ENERGY STAR EVSE Draft 2 Stakeholder Comment Summary and Response

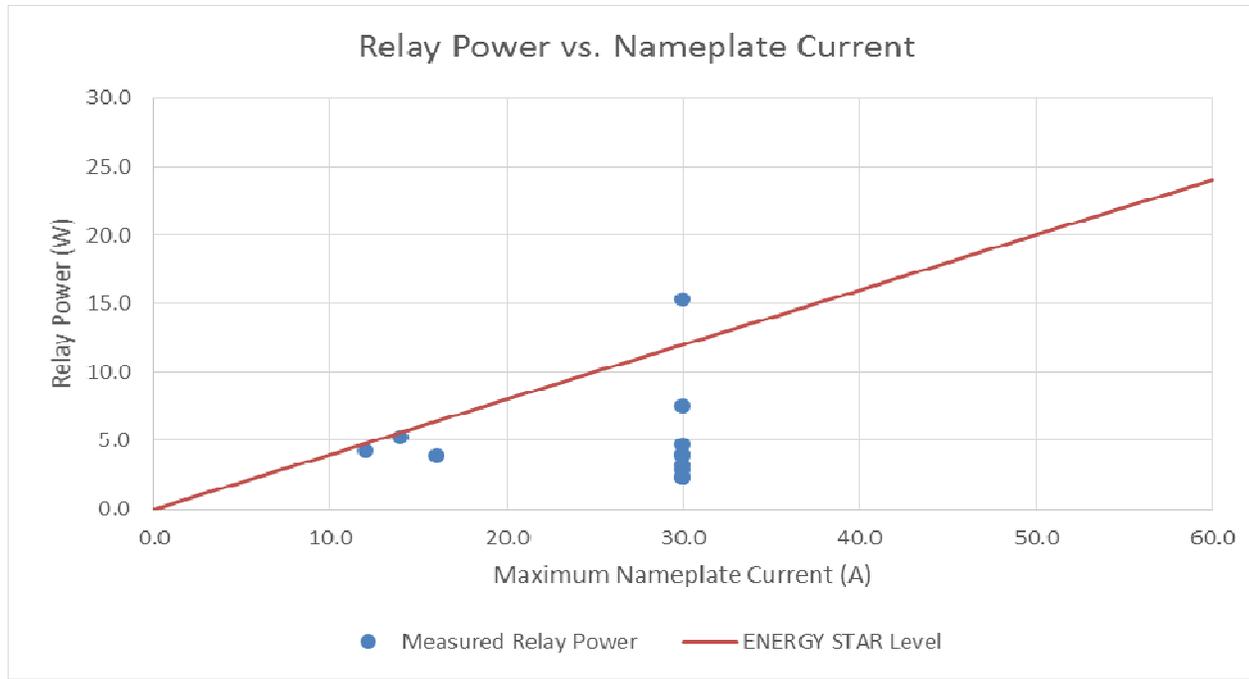
Idle Mode	Relay Power	Two stakeholders recommended that EPA remove requirements for the efficiency of the relay noting that the size and quality of a relay is dictated by electrical safety standards. In addition, durability and reliability is tied to the quality of a relay chosen for an EVSE. They noted that setting a threshold for energy loss for a contactor would only force EVSE manufacturers to undersize a critical functional safety component in the system.  One of these stakeholders noted that the comment period did not provide enough time to assess the appropriate relationship between the size of an EVSE and the power consumption required for a relay. The other stakeholder stated that ENERGY STAR mandates safety requirements for electric water heaters.  In addition, both of these commenters strongly urged EPA to require NRTL certification for any product that will be certified to ENERGY STAR because safety can be sacrificed to achieve lower power consumption, and products are not currently required to meet NRTL certification to be sold in the U.S. In order to maintain safety and the quality of the ENERGY STAR brand, they recommended that a NRTL certification is necessary. One stakeholder noted that this is the only standard (NEC Section 625 EVSE and UL 2594) that is accepted in the US.  Finally, one stakeholder supported the efforts to collect additional information to determine an appropriate relay power allowance that accommodates safety functions, while encouraging energy efficiency.	EPA appreciates this feedback from stakeholders and, as a result, has changed the approach to calculating the Maximum Idle Mode Power Requirement. In the Draft 2 Specification, relay power was provided an allowance $0.25 * \text{Max Current}$ . In the Final Draft Specification, EPA has increased this allowance to $0.4 * \text{Max Current}$ following another review of the dataset and stakeholder feedback on the importance of right-sizing the relay for the size and safety of the EVSE. EPA's proposed change will allow all products with the exception of outliers to meet the requirements for relay power. Doing so will help differentiate models with significantly larger relay powers than those that have the same maximum current. The Relay Power graph demonstrates this.  Due to stakeholder input on the importance of ensuring that products seeking to meet the ENERGY STAR also meet current voluntary safety standards, EPA has added a requirement for the NRTL certification, the national standard for used by EVSE stakeholders to denote product safety. EPA seeks to ensure that products meeting the ENERGY STAR also meet consumer quality expectations.
